SUPPLEMENTAL / BID BULLETIN NO. 01

TITLE : Supplemental Bid Bulletin for the **Procurement of Supply, Delivery, and Installation of Structured Cabling System in DSWD Regional Center**

ITB NO. : **DSWD12-2023-RICTMS-014**

DATE : 26 June 2023

Structured Cabling Plan 1st floor to ground floor

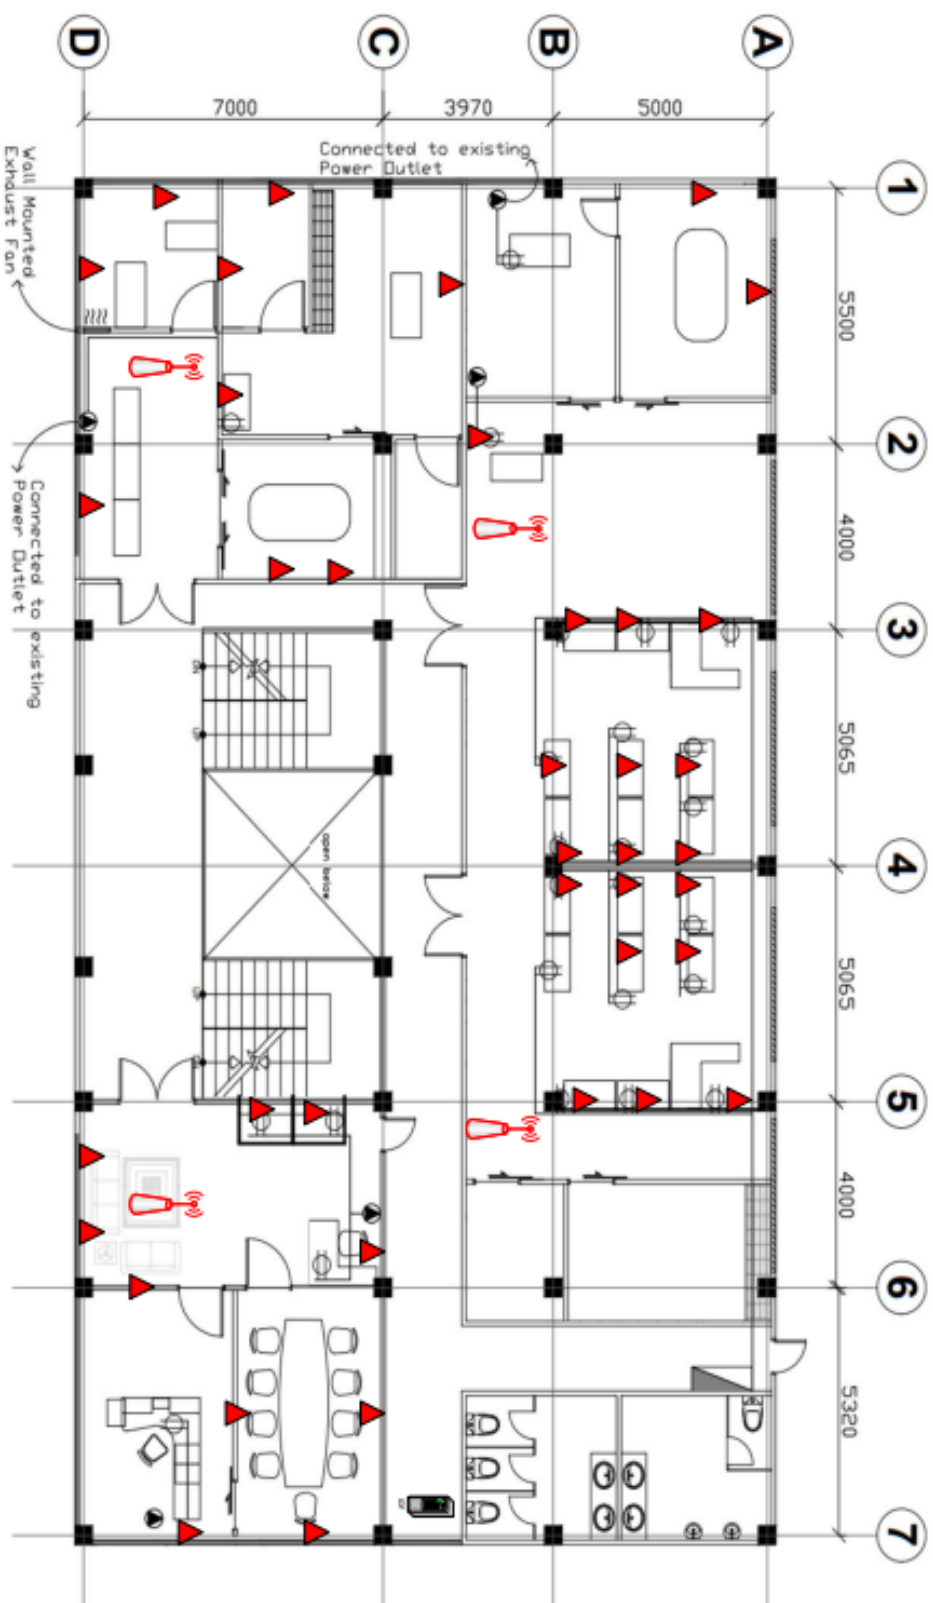
Amendment on Section III Bid Data Sheet	
<u>Item No. 15</u> DO NOT OPEN BEFORE: <u>04 JULY 2023; 2:30 P.M.</u>	DO NOT OPEN BEFORE: <u>05 JULY 2023; 11:30 A.M.</u>
Amendment on Section I INVITATION TO BID	
During the pre-bid conference, a query was raised regarding whether the procuring entity could provide bidders with a structured cabling plan as a basis for computing bid costs. The Bids and Awards Committee, along with its Technical Working Group and End-users, agreed to include this information in the supplemental bid bulletin.

- PROPOSED NUMBER OF NODES: 58
- PROPOSED NUMBER OF WAP: 5
- PROPOSED NUMBER OF DATA BACK: 1
